PROJECT: Thoreau Elementary School Interior Renovations
PRA PROJECT NUMBER: 260027-01
DATE: 20 APRIL 2026

SUBJECT: **ADDENDUM NO. 01**

Thoreau Elementary School Interior Renovations

S100

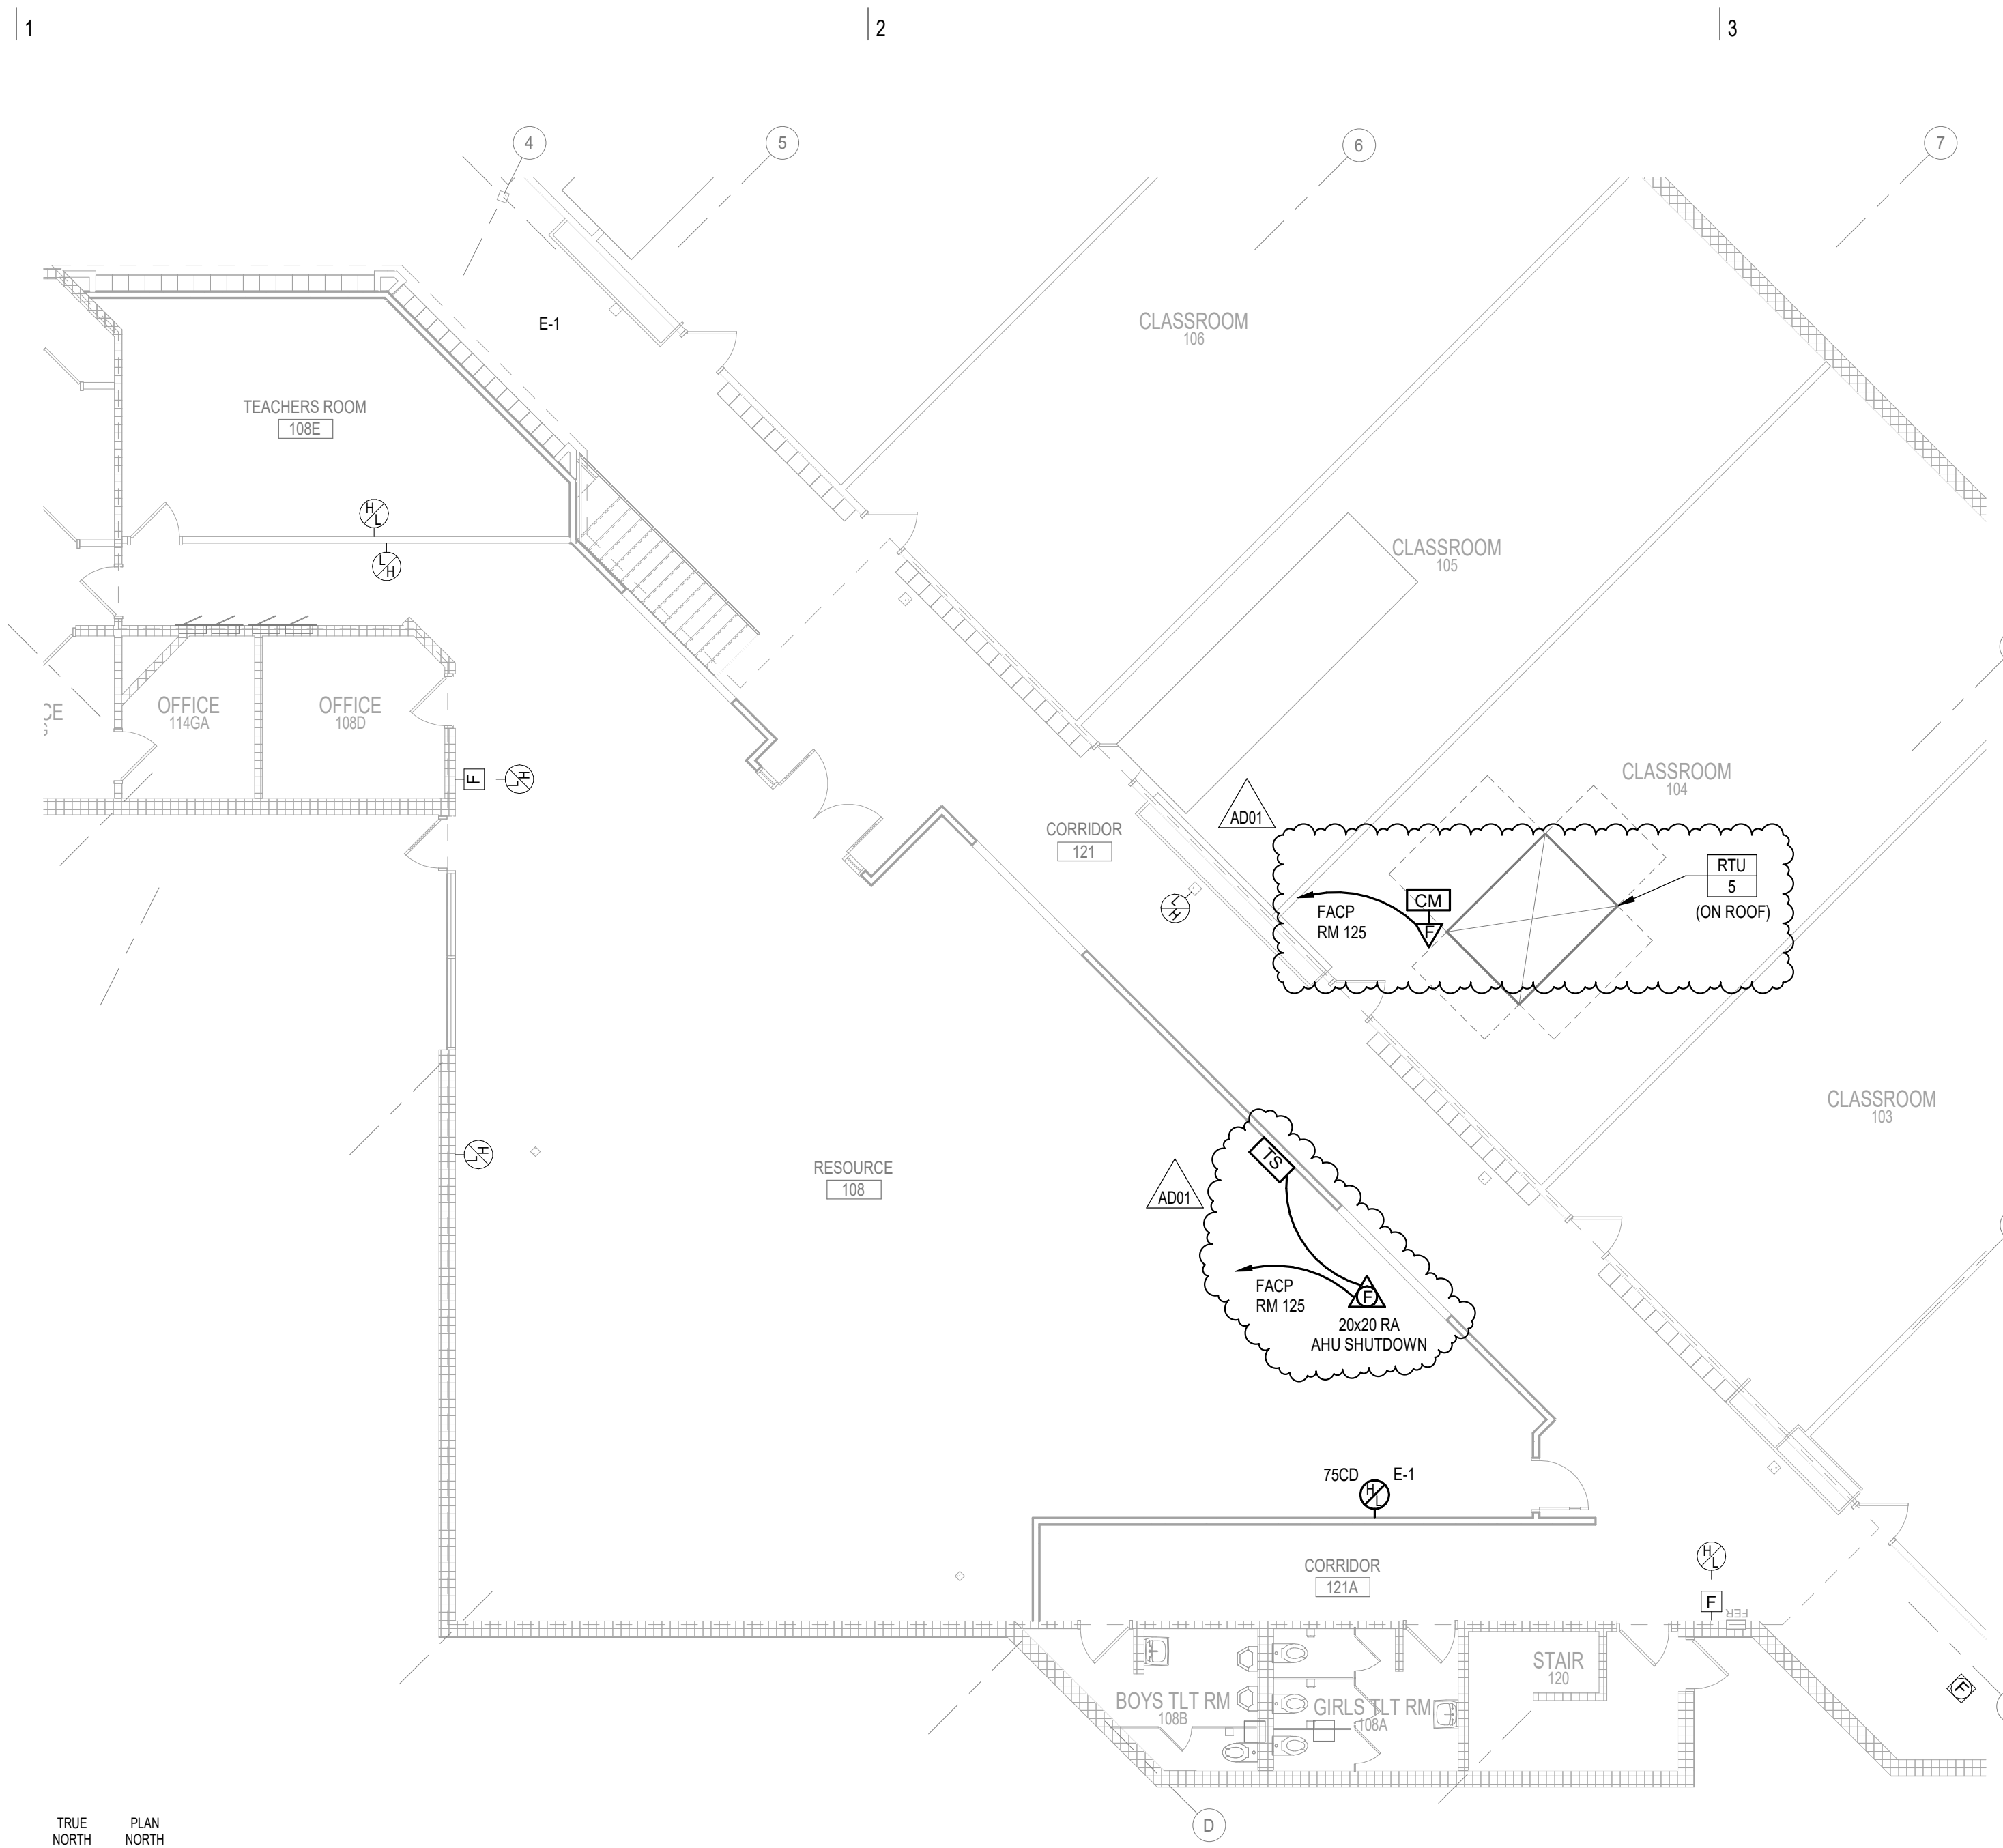
A. S100 – ROOF FRAMING PLAN

1. ADD: Add sheet S100 to the project, see attached for sheet S100.

TRUE NORTH PLAN NORTH
PARTIAL FIRST FLOOR FIRE ALARM PLAN
 1/8" = 1'-0"

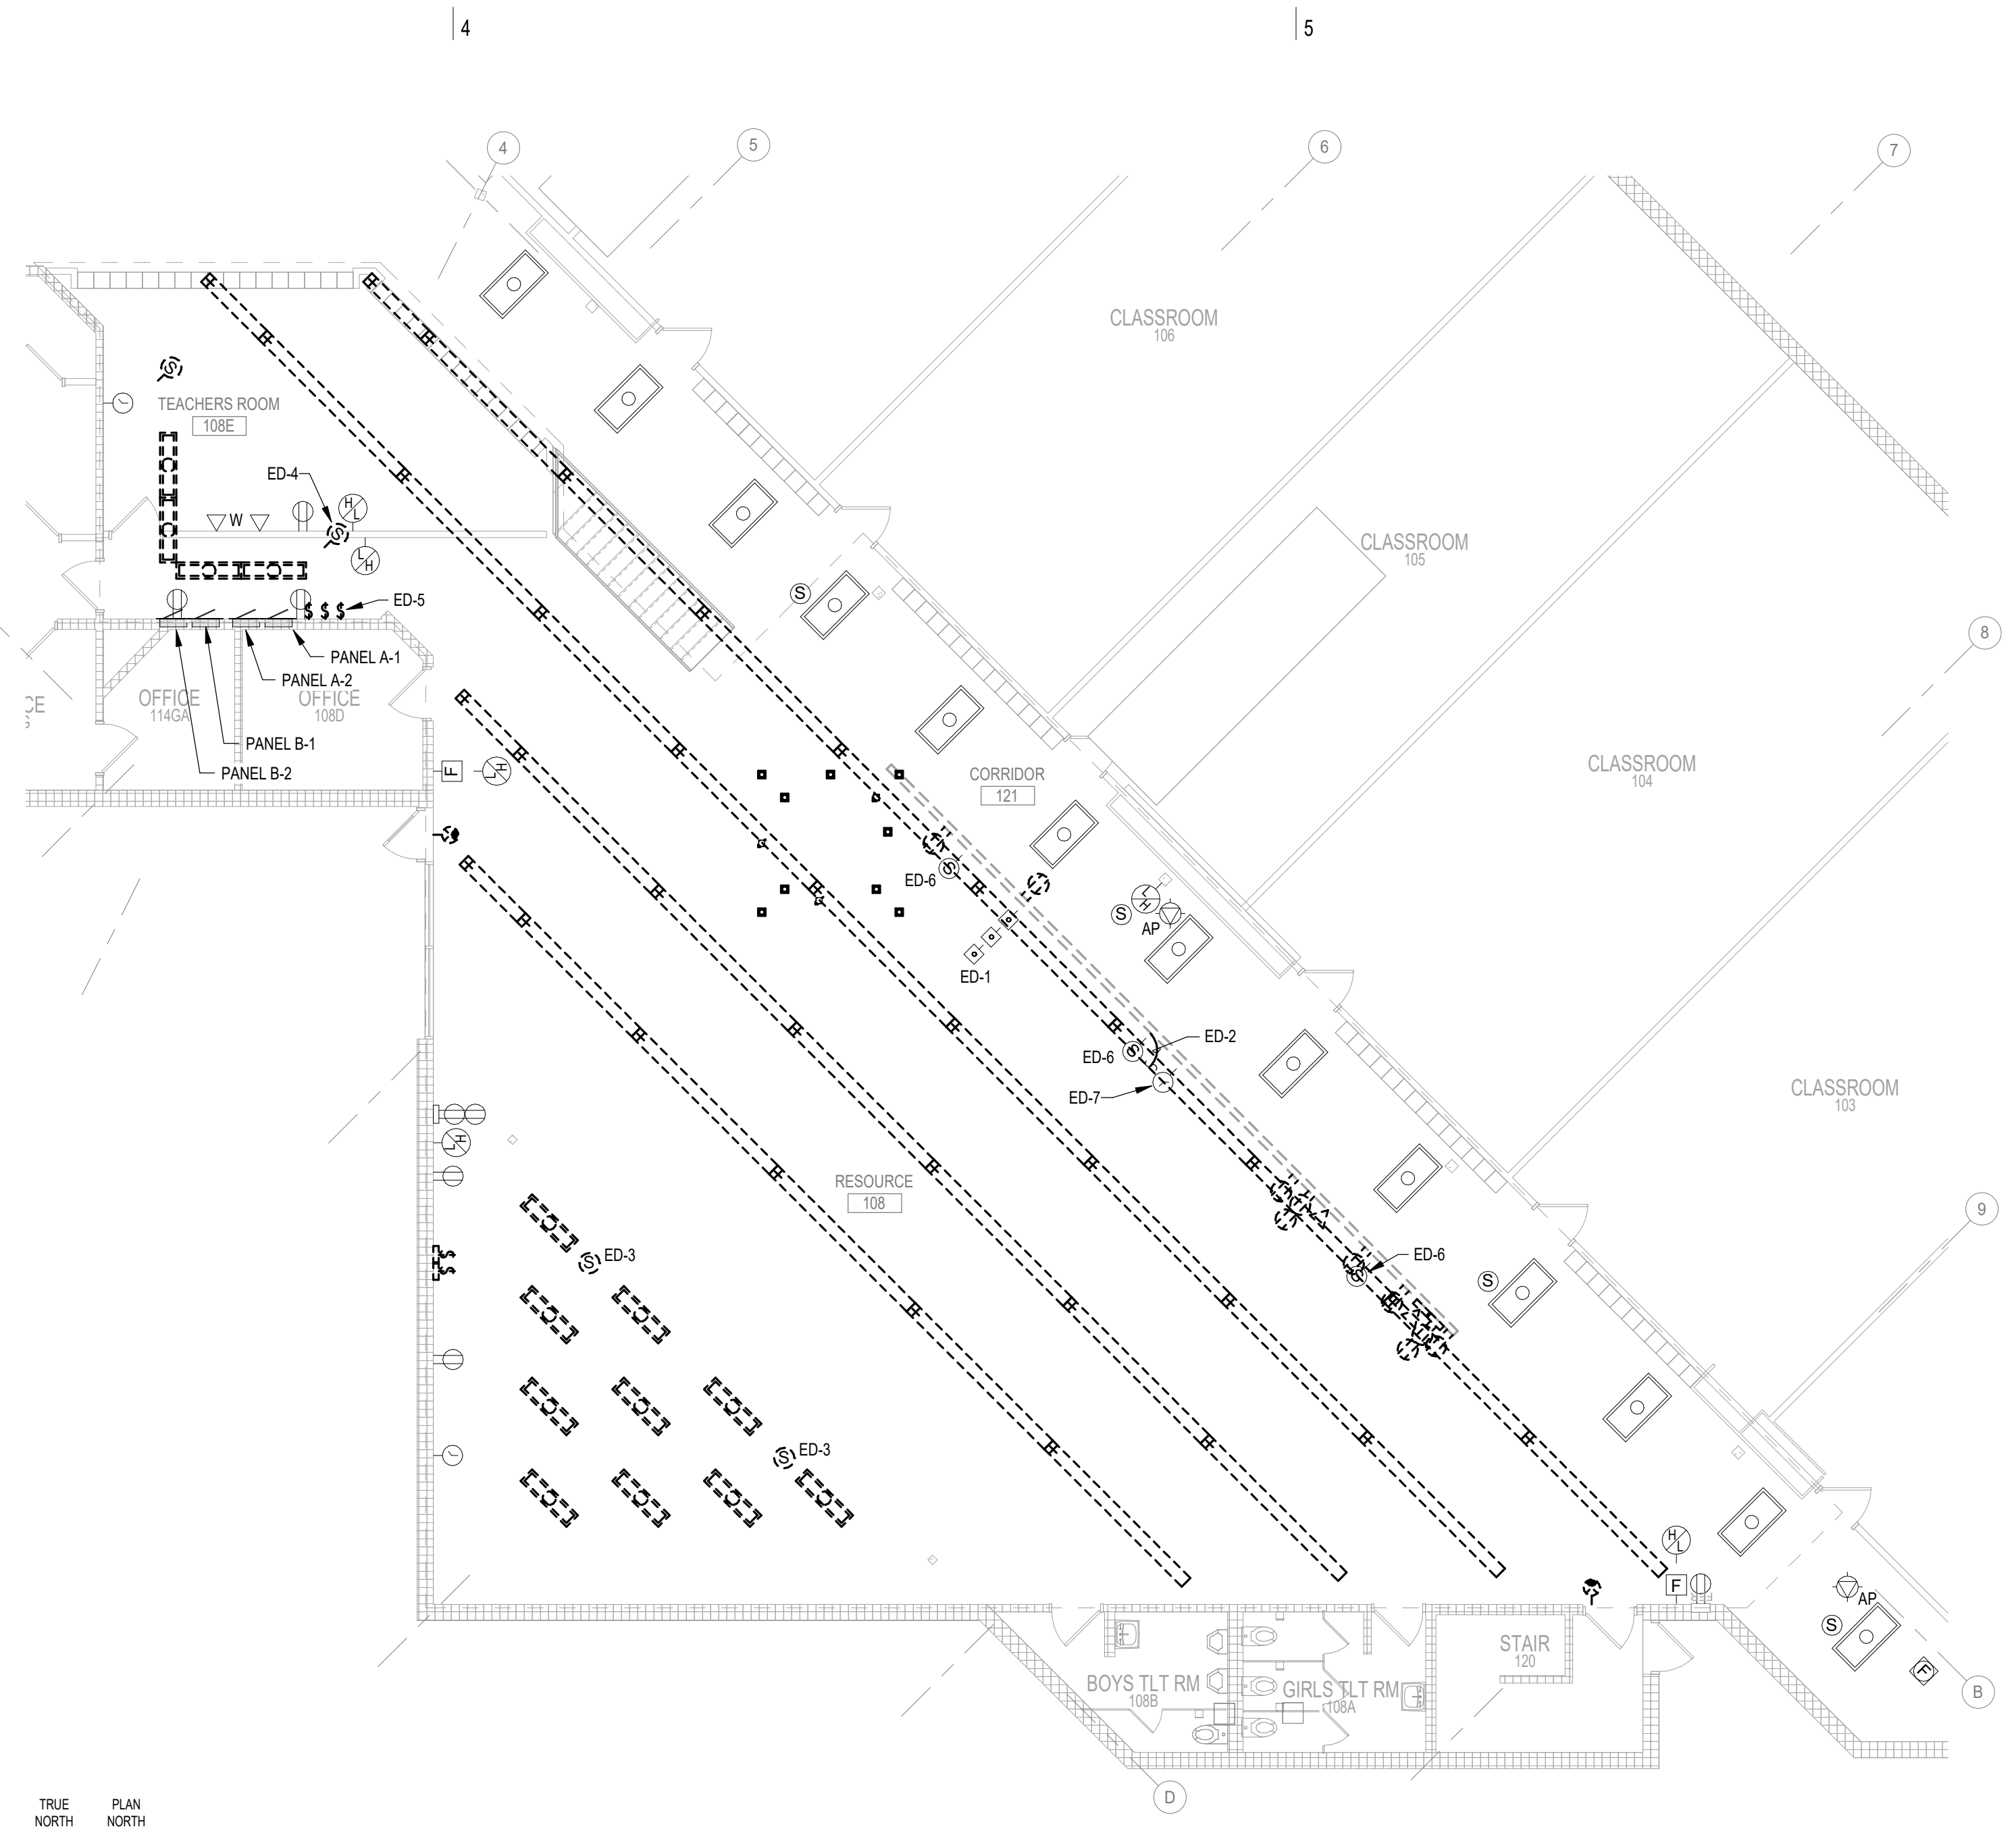
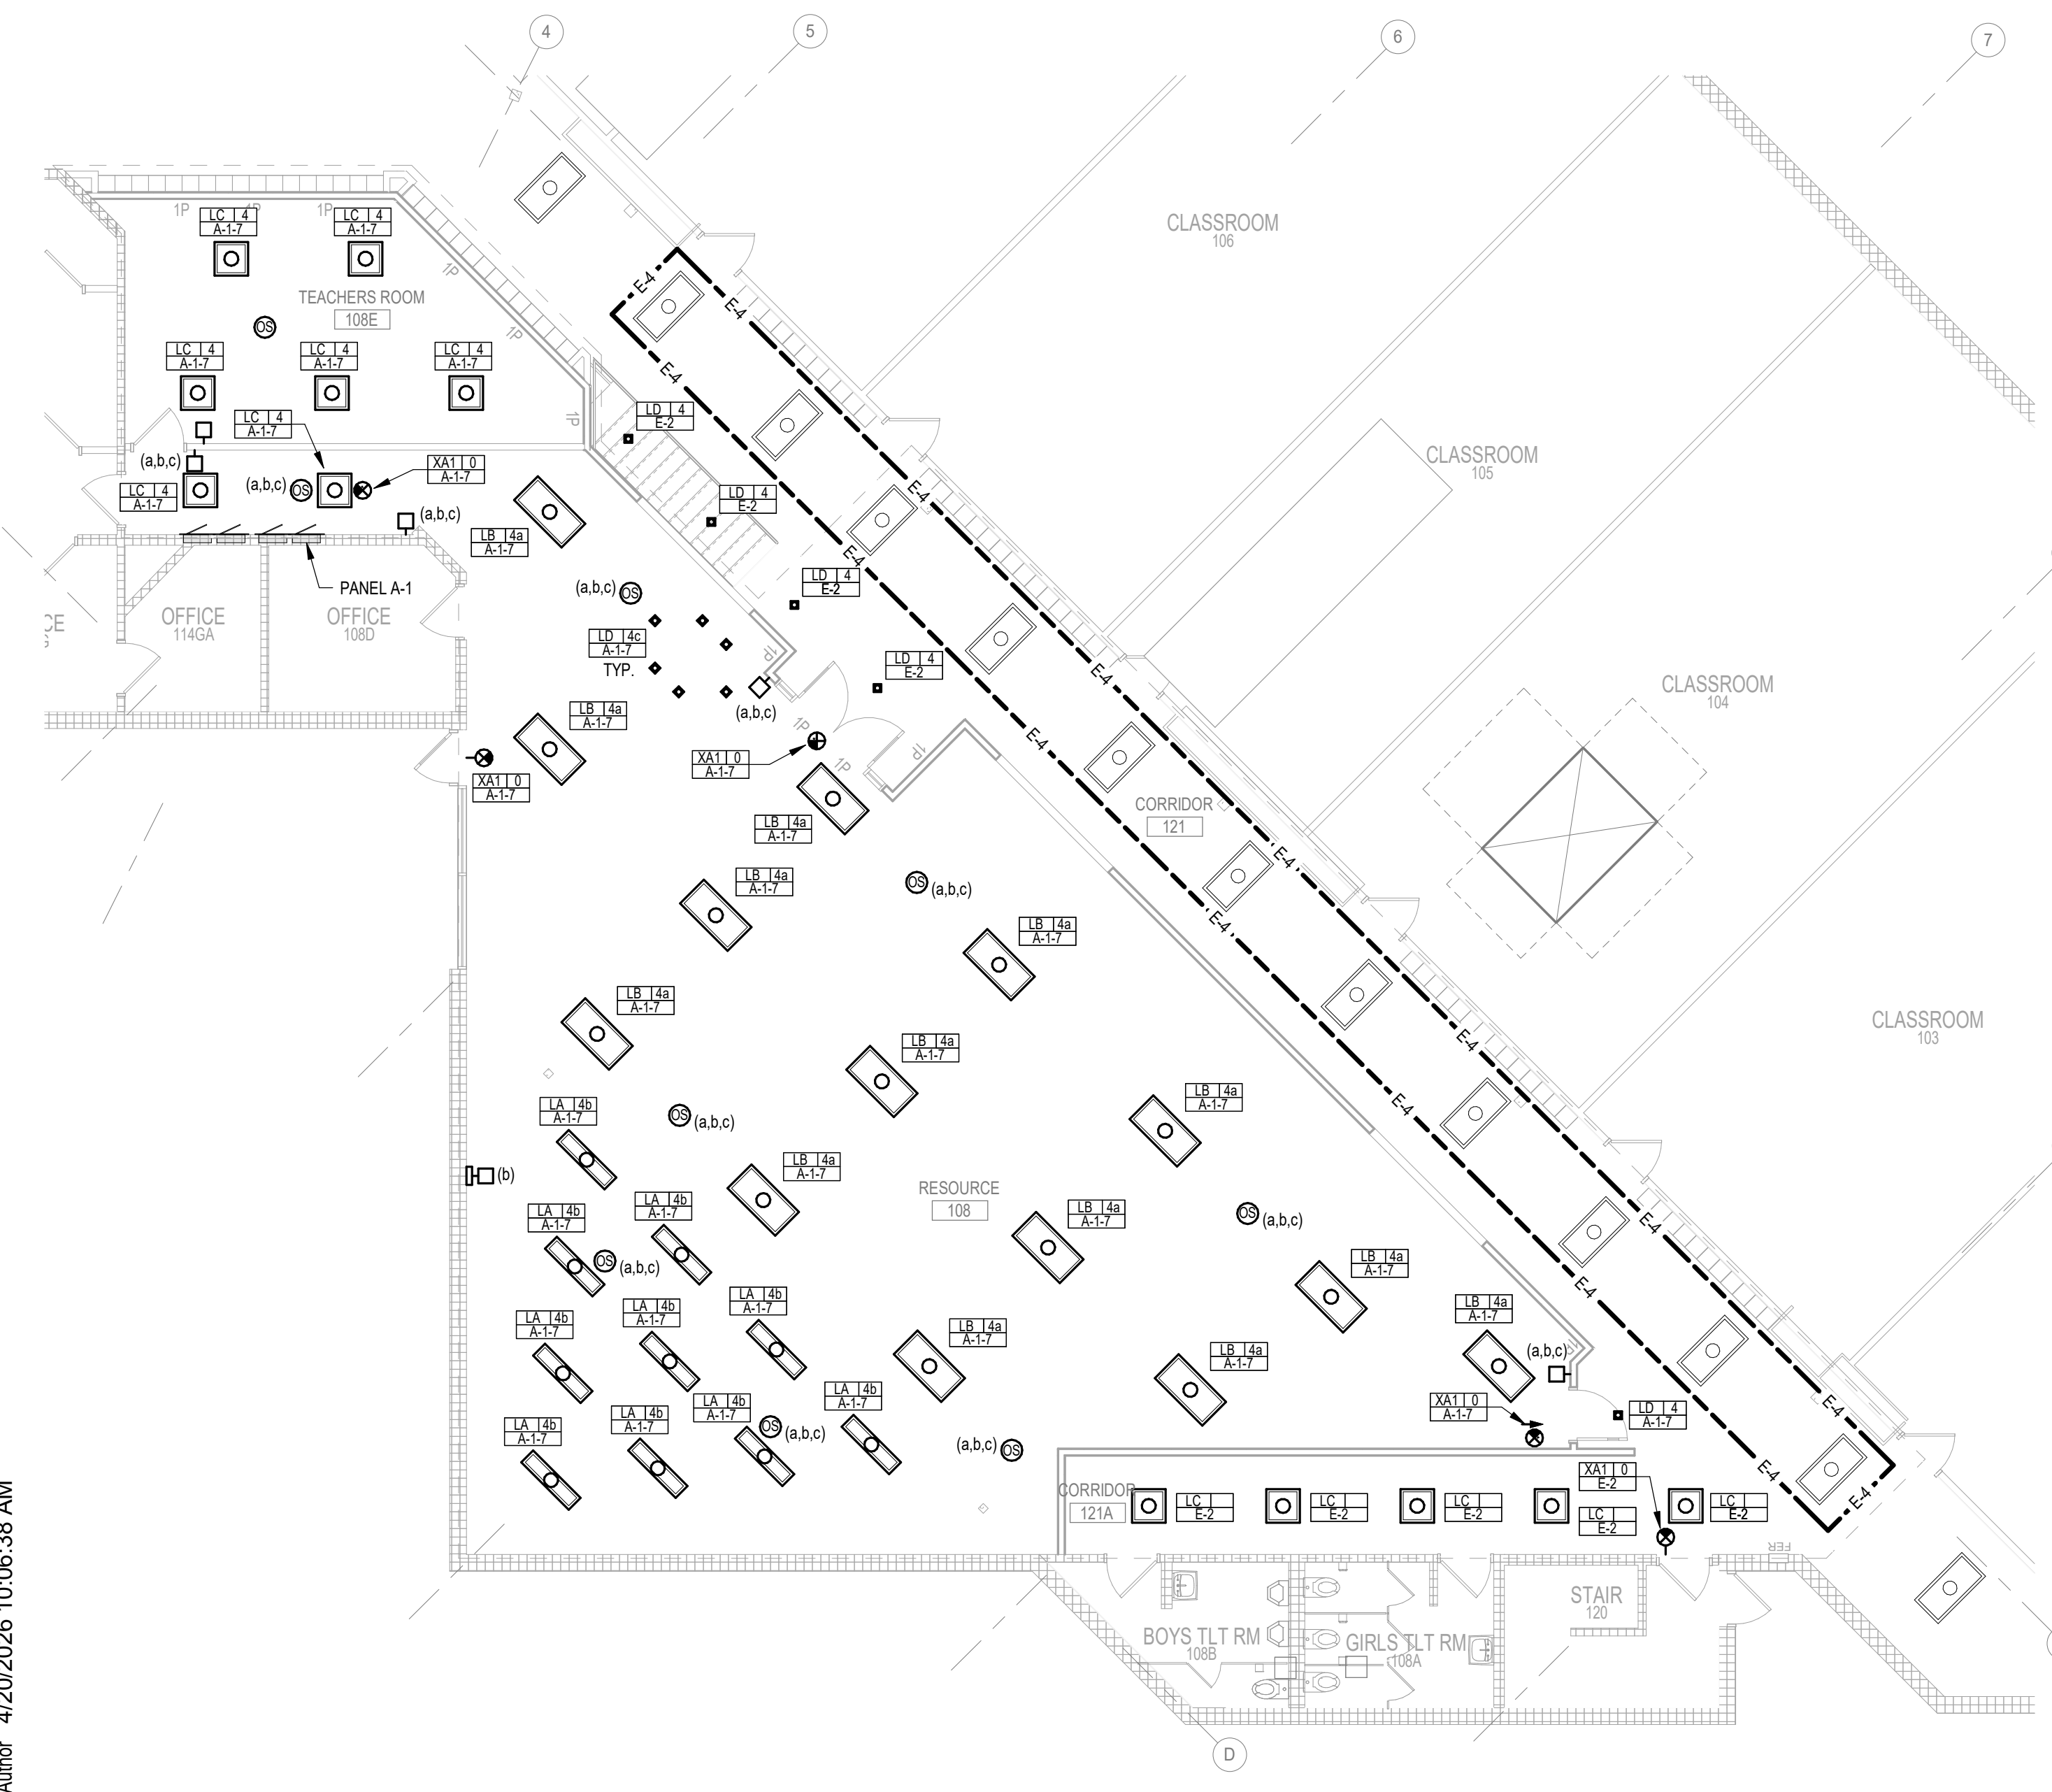
A. E200 – PARTIAL ELECTRICAL PLANS

1. REVISE: Revise plans as shown on attached revised sheet E200.
